PRODUCT / PROCESS CHANGE INFORMATION

1.1 Company		STMicroelectronics International N.V
1.2 PCI No.	MDG/23/13817	
1.3 Title of PCI	BlueNRG-LPS (BlueNRG-332x) seal ring compatibility with WLCSP Package	
1.4 Product Category	BlueNRG-332x	
1.5 Issue date	2023-01-09

**BlueNRG-LPS (BlueNRG-332x) seal ring compatibility with
WLCSP package**

Current	New
Diffusion FAB	TSMC FAB14 (Taiwan)	
Seal ring	 <p>corner with square edges</p>	 <p>corner with beveled edges</p>
Marking	No marking change

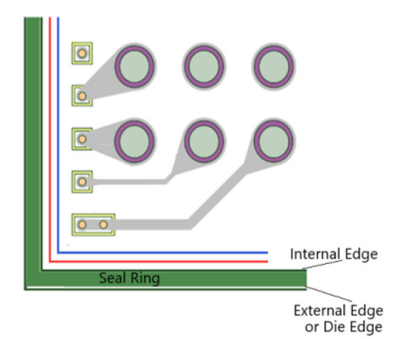
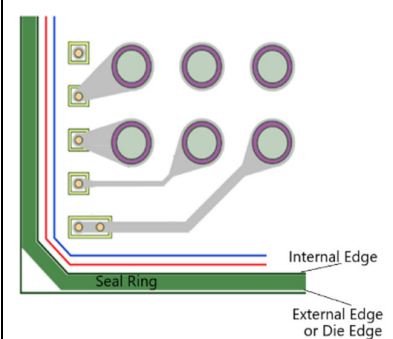
Square edge Seal Ring used for QFN32 is not compatible with WLCSP package. Beveled edge seal ring is mechanically more reliable for WLCSP and is also reliable for QFN package. Uniformization of the seal ring is mandatory for manufacturing flexibility.
